AEMO review of technical requirements for connection final report: Appendix 2

22 December 2023

*Stakeholder consultation analysis and revised recommendations –
NER Schedules 5.2 & 5.3a*

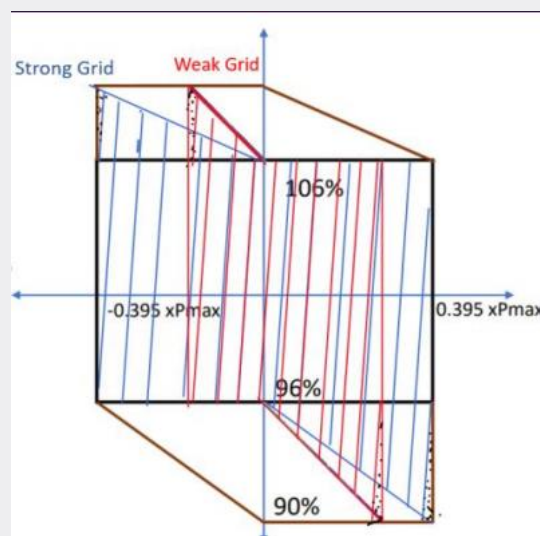
AusNet believes that the efficient voltage-dependent reactive power curve should be as follows, which can form a basis for the NAS. It can be provided in the assessment guideline or approach paper setting up as a recommended negotiation principle.

- For a key voltage bus node where the voltage is meant to be tightly controlled, the UQ profile similar to the GB grid code (as mentioned in Bo Yin's response to the Draft Report) utilises plants' capability more effectively which takes the high dV/dQ sensitivity into account.

- For the bus nodes that are not remote from system strength nodes on the transmission level and are regularly experiencing bidirectional load flow may require more network voltage control support. Under such circumstances, the wider-band UQ profile (e.g., strong grid in the image above) provides more resilience assuming the Q margin (i.e., away from knee point of QV curve) and stability margin (i.e., away from stability limits) are well maintained.

negotiation of lower requirements where appropriate. AEMO acknowledges the proposed AAS is more onerous than many international standards, but it should be noted that those are mostly mandatory standards.

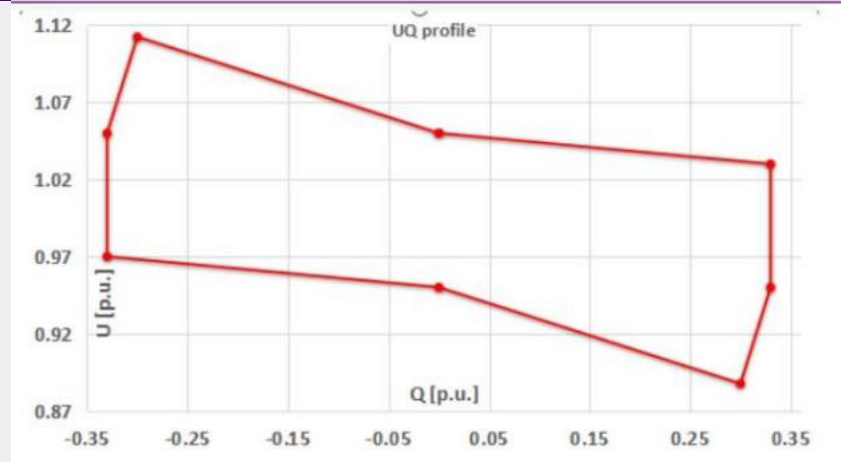
Bo Yin's submission comments that the amount of reactive power required at low SCR to achieve voltages in the range 90 -110% is much less than 0.395 pu because of high dV/dQ sensitivity. BoYin suggests that AEMO should investigate the amount of reactive power actually being utilised by power plants.

Bo Yin suggests that the requirement for reactive power injection at low voltage should be balanced against the cost of providing it. He suggests the following:
